MIL "ON" DTC P3190 - (Poor Engine Power) at High Altitude With High Temperatures

Service Category Vehicle Interior

YEAR(S)	MODEL(S)	ADDITIONAL INFORMATION
2017 - 2018	Highlander HV	VDS(s): BGRFH, DGRFH, JGRFH

Figure 1. Location of Authorized Modifications Label for 2017 – 2018 Highlander HV

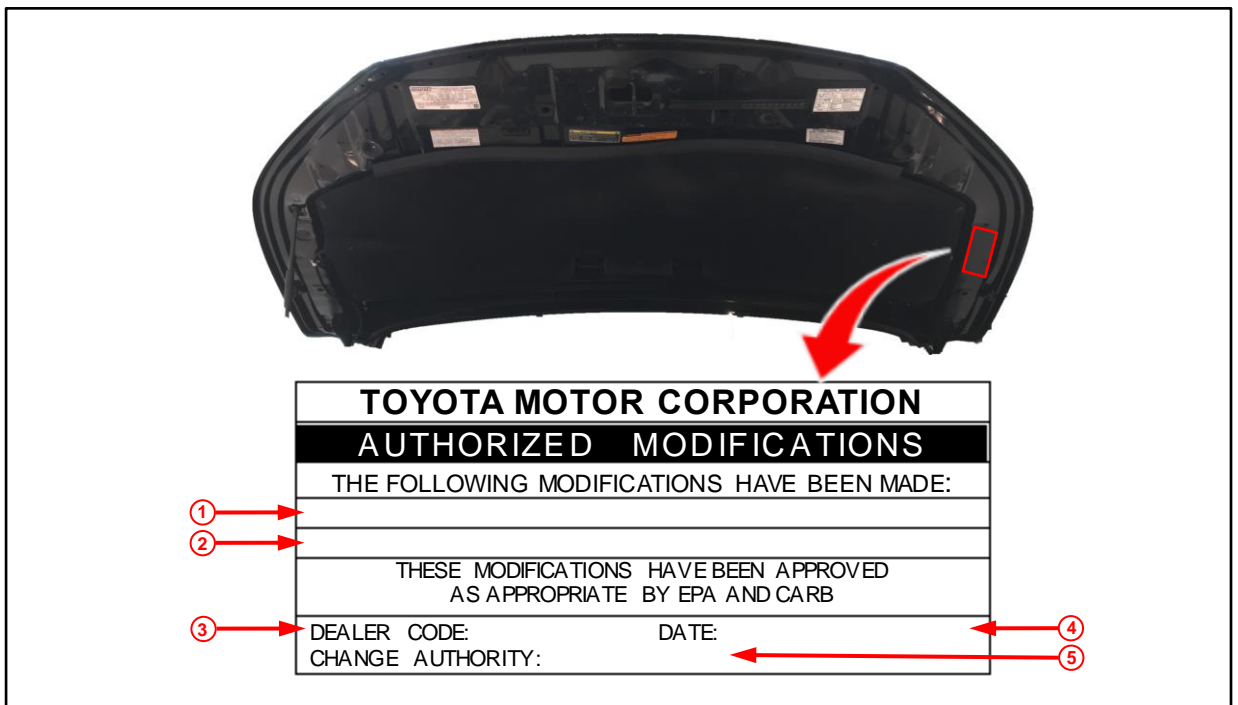
5. Check for the Authorized Modifications Label affixed to the vehicle in the location shown below. Confirm if the ECM (PCM) calibration has been updated.

Is the calibration ID listed the latest ECM (PCM) calibration?

7. Prepare and install the Authorized Modifications Label.
 - A. Using a permanent marker, enter the following information on the label:
 - ECM (PCM) part number [*Refer to the **Parts Information** section for the **NEW PART NUMBER***]
 - Calibration ID(s) [*Refer to the **Calibration Information** section for the **NEW CALIBRATION ID***]
 - Dealer Code
 - Repair Date
 - Change Authority [***This bulletin number***]
 - B. Affix the Authorized Modifications Label to the vehicle at the location shown in Figure 1. The Authorized Modifications Label is available through the MDC, P/N 00451-00001-LBL.
8. Perform a Health Check to confirm that the NEW calibration updated successfully.
9. Ready the vehicle ON, warm it up to normal operating temperature, and test drive to confirm proper vehicle operation.
